**Fareham Borough Council - Relevant Representation
Hampshire Water Transfer and Water Recycling Plant Development Consent Order
Application by Southern Water Services Limited**

Following the Planning Inspector's confirmation that the above project has been accepted as an application for a Development Consent Order (DCO) to construct a Water Recycling Plant at Broadmarsh in Havant, and to run a pipeline from the Havant Thicket reservoir to Otterbourne Water Plant near Winchester, Fareham Borough Council (the Council), as one of the host authorities, requests to be registered as an Interested Party at the Examination.

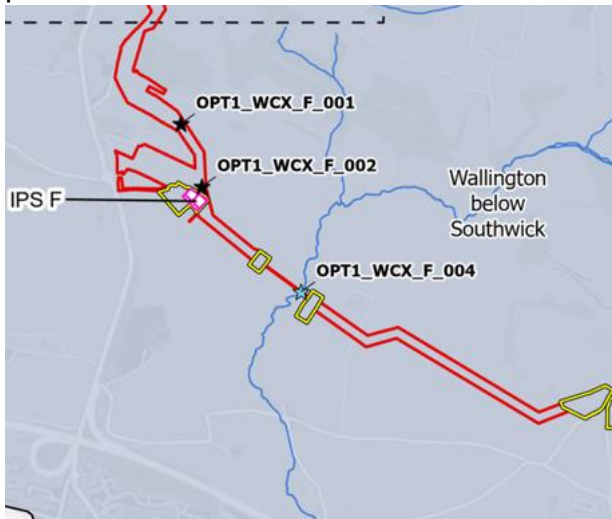
Whilst there will be a 15m buffer between Carpenters Copse Ancient Woodland/SINC and the works, there will be medium-term severance of the woodland/hedgerow network connected to this Ancient Woodland in areas shown below in yellow. Therefore, FBC is not clear why the modelling and survey work (statics and nighttime bat walkovers) did not cover this area, as a sampling location and key connective location, for the presence of bats, particularly Annex II bat *Barbastelle*. Instead, a static was placed at the crossing with the River Wallington, where the impact is limited due to the trenchless nature of the crossing. Given the large number of Ancient Woodlands located to the east, west and north of Carpenters Copse, it is not considered that sufficient survey work has been carried out to understand the baseline and enable impact assessment/proportionate mitigation in the areas to be affected as a result of severance of commuting routes for bat populations.

Whilst the woodland and scrub planting around the proposed Intermediate Pumping Station-F is supported, it is not clear if there will be any requirement for external lighting of the station during the operational phase. Furthermore, is there any scope for further planting to increase ecological connectivity in this area and help with achieving more on-site BNG.

Clarification is required if Compound F-1 is located at least 30m away from River Wallington and if any night-time lighting of the compound during the construction phase will be required.
